South King Fire and Rescue

Station 63 Facility Improvements

ADDENDUM #1

December 16, 2016

MSK-3

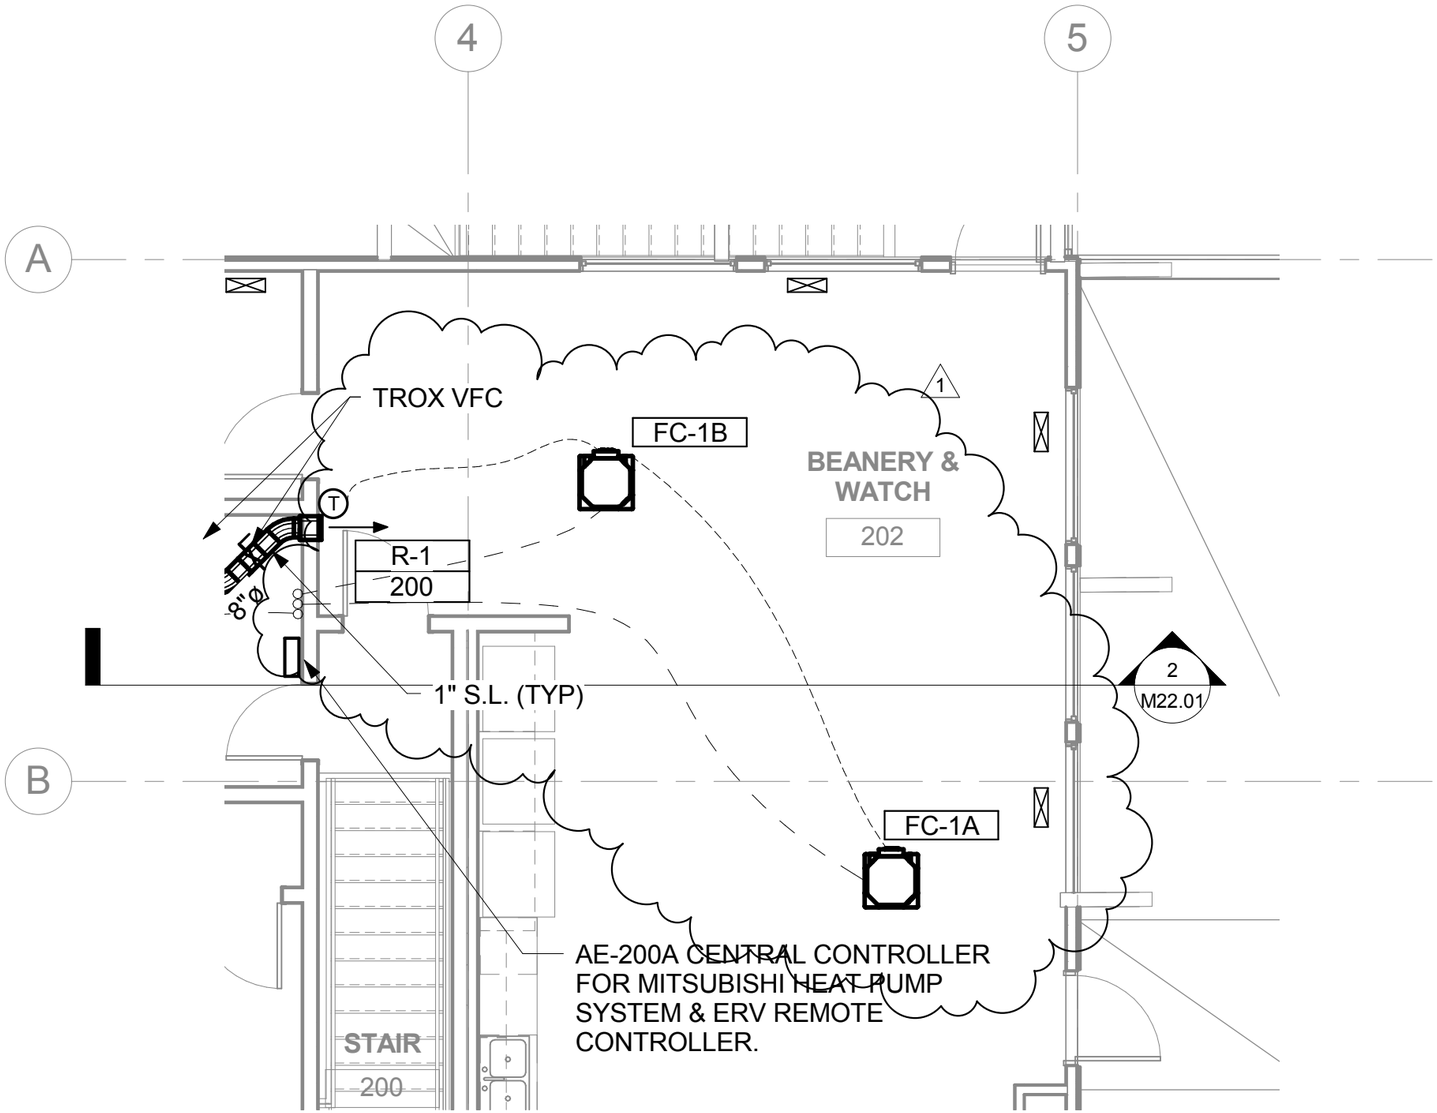
ITEM 24. M21.12 **Remove** FC-1 and **replace** with FC-1A and FC-1B, see MSK-3.

P21.11

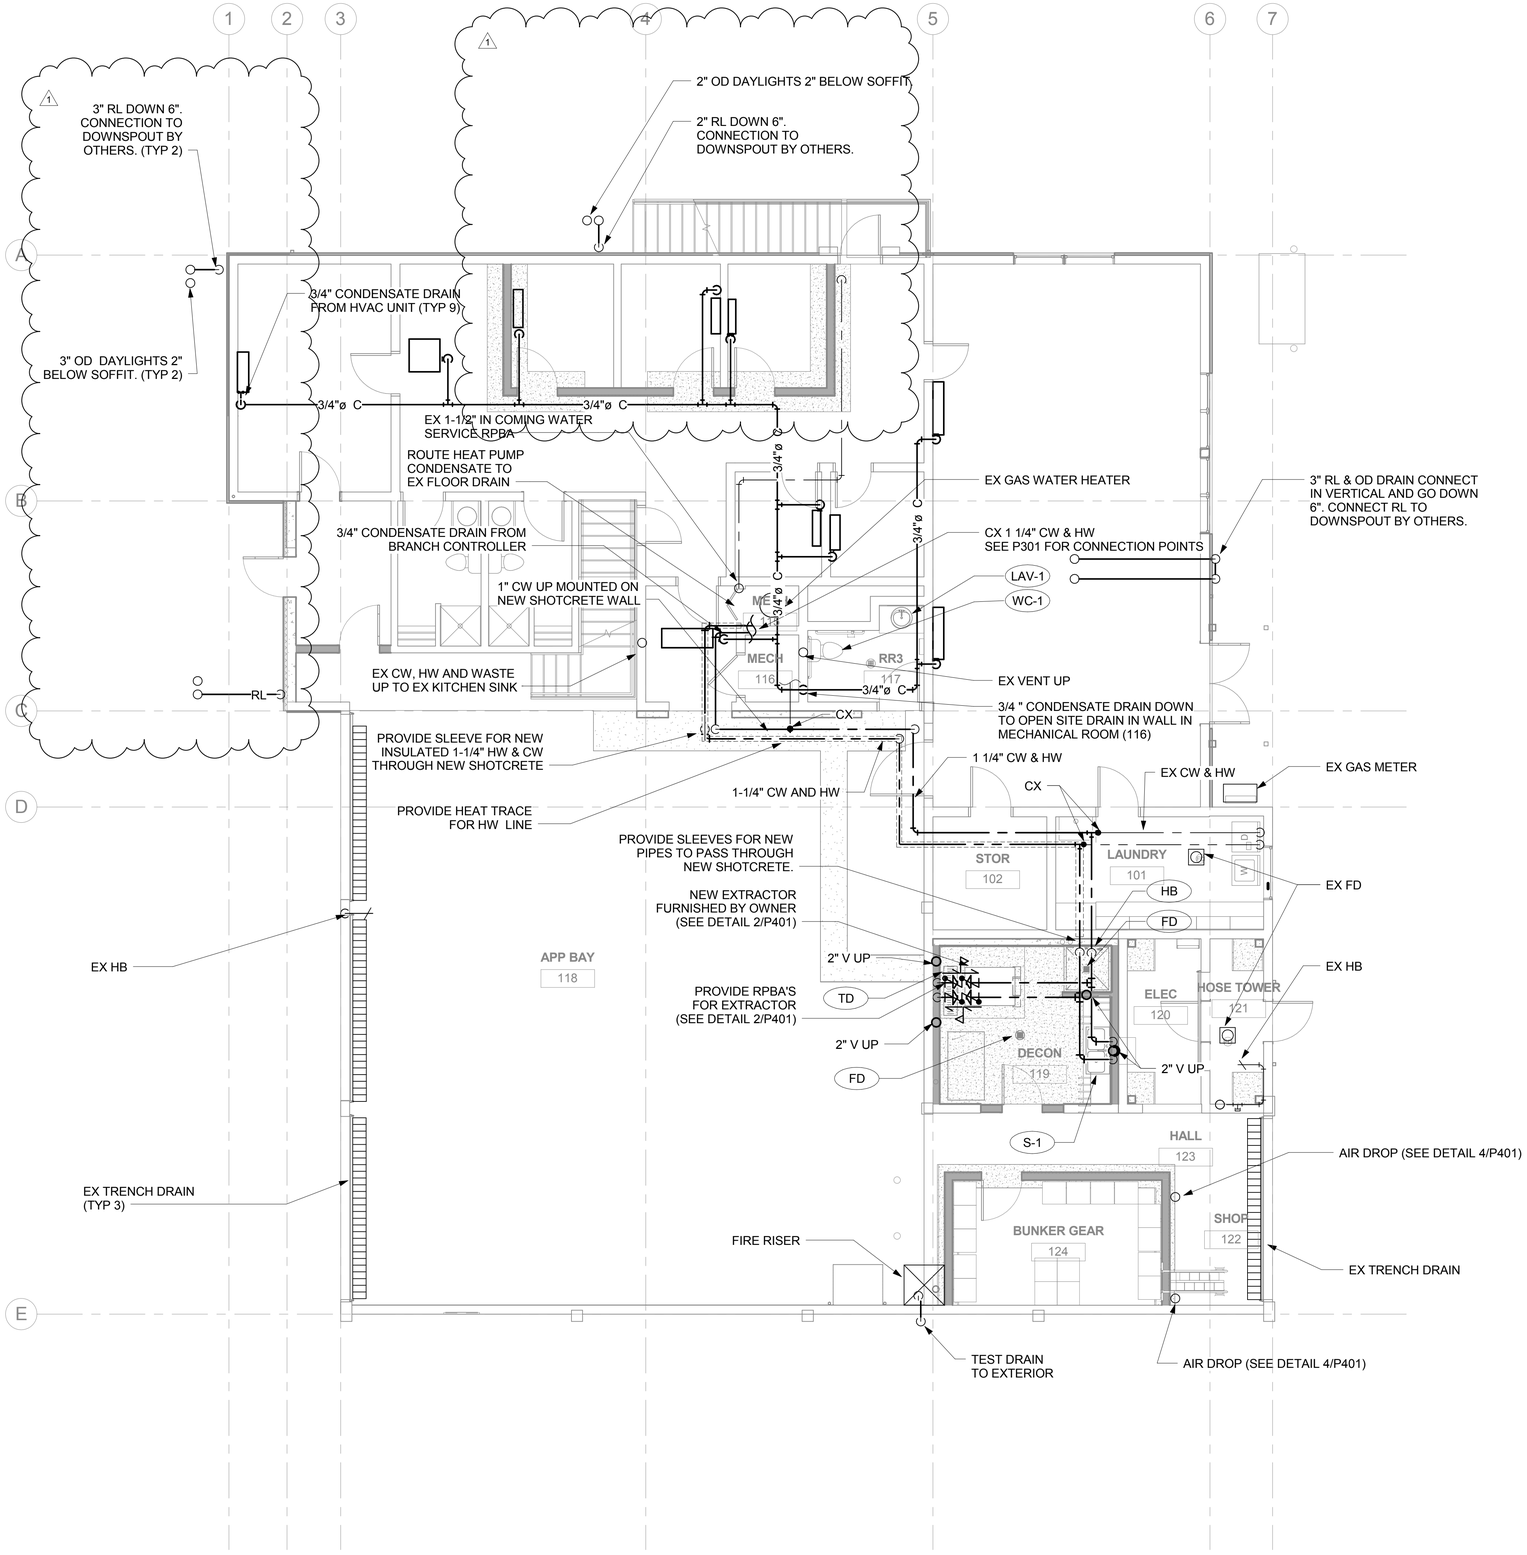
ITEM 28. P21.11 **Revise** condensate piping, roof and overflow drainage. See revised P21.11.

P21.12

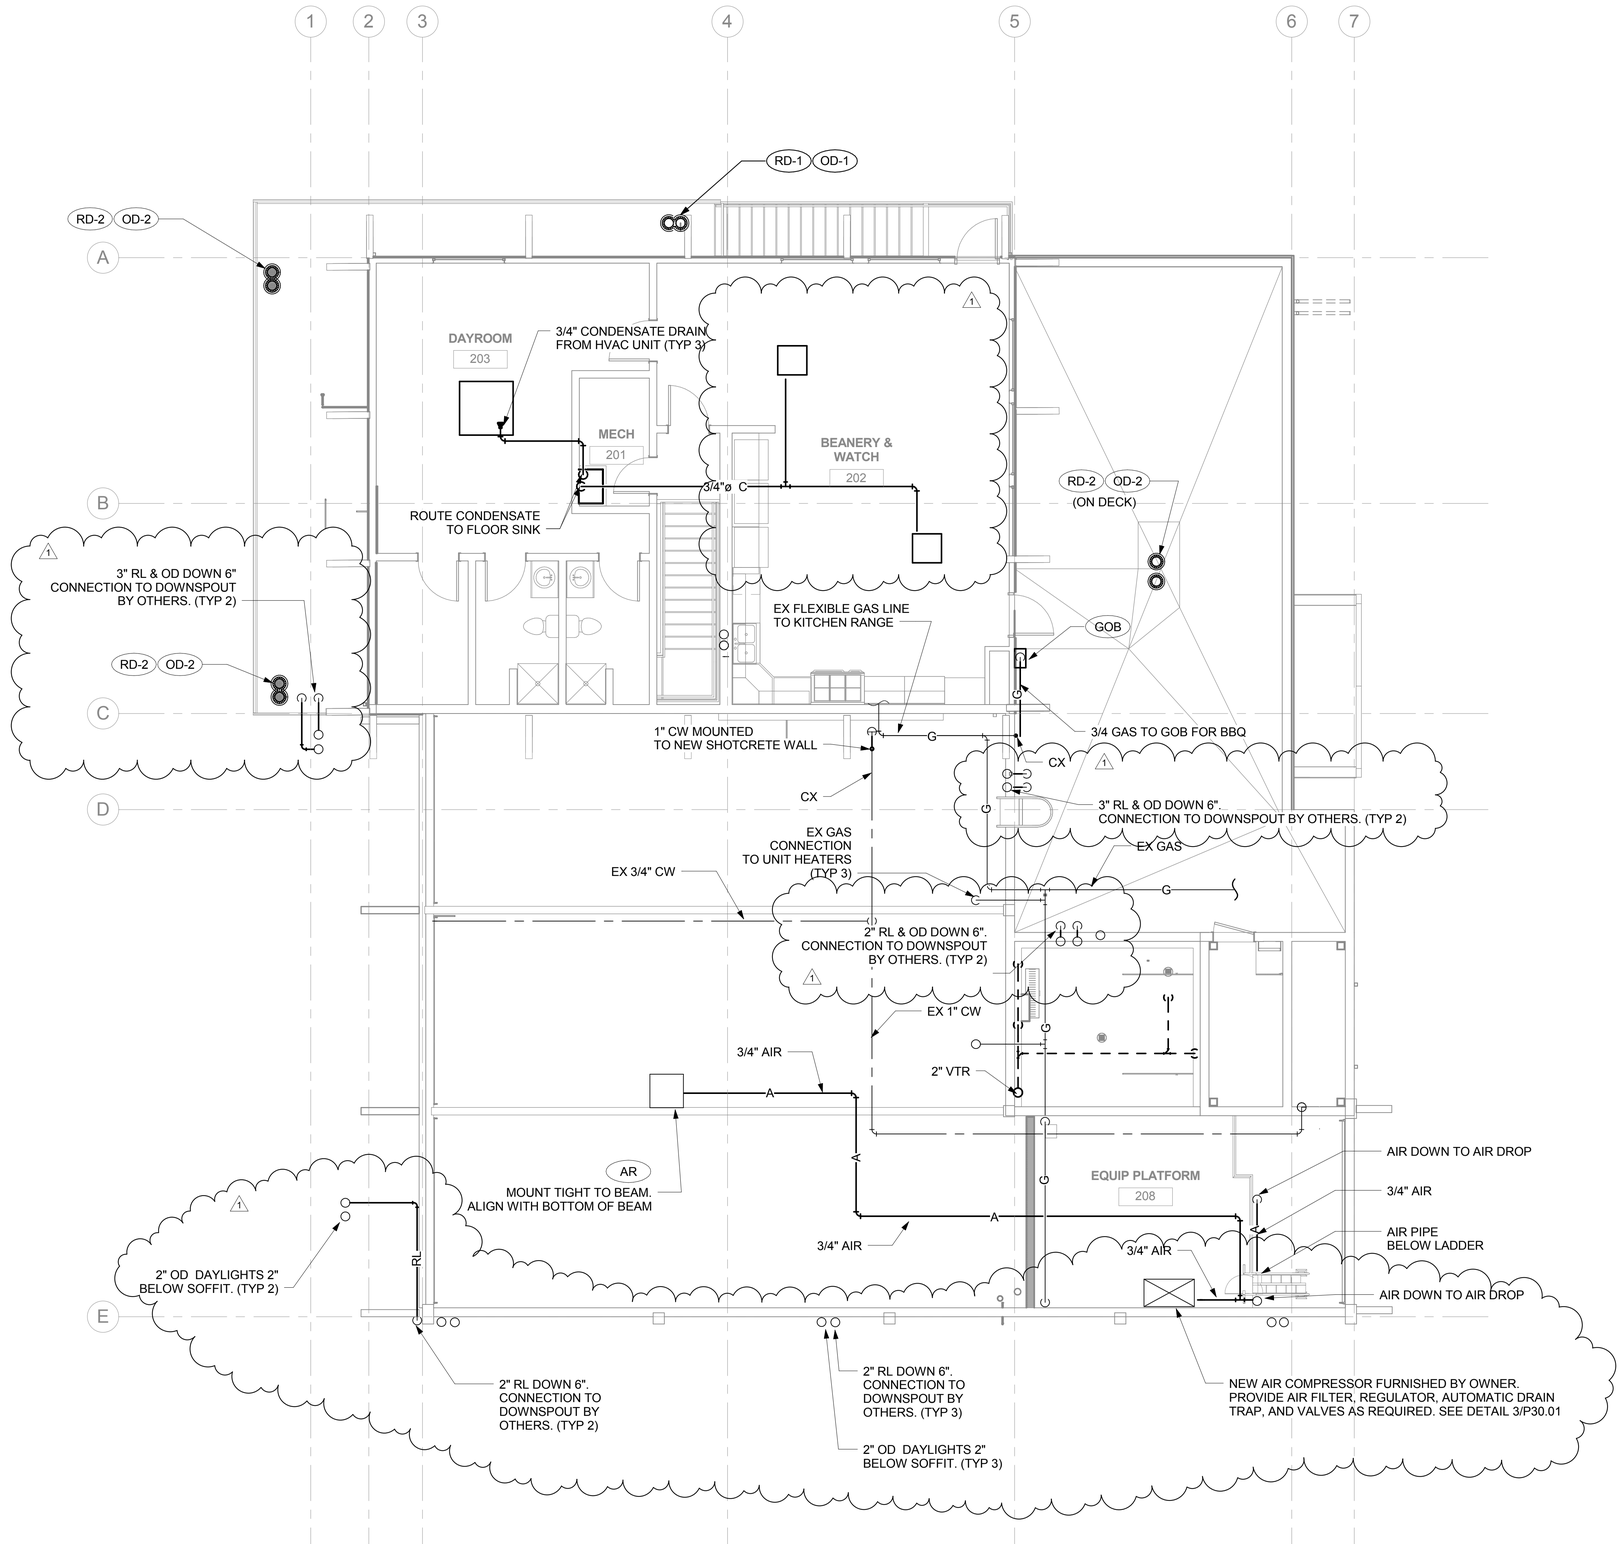
ITEM 29. P21.12 **Revise** condensate piping, roof and overflow drainage. See revised P21.11.

PSK-1

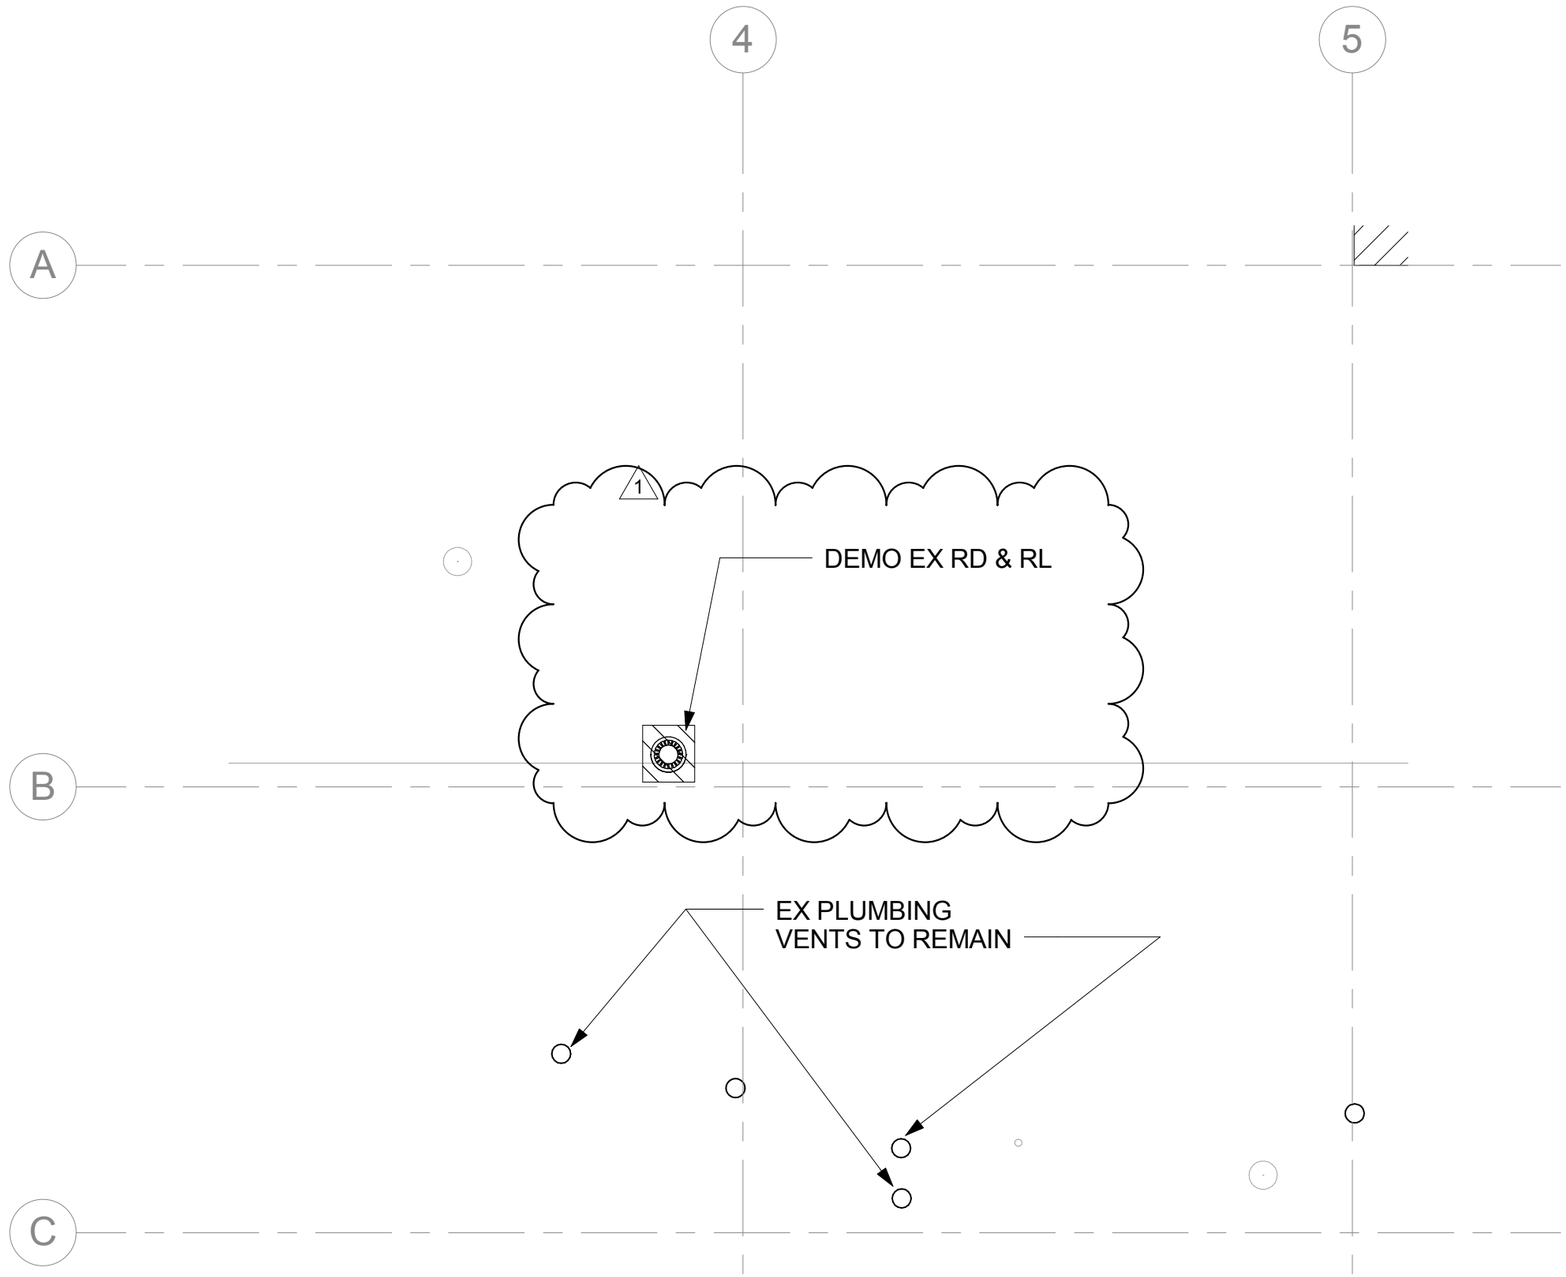
ITEM 27. P20.13 **Demo** existing roof drain, see PSK-1.
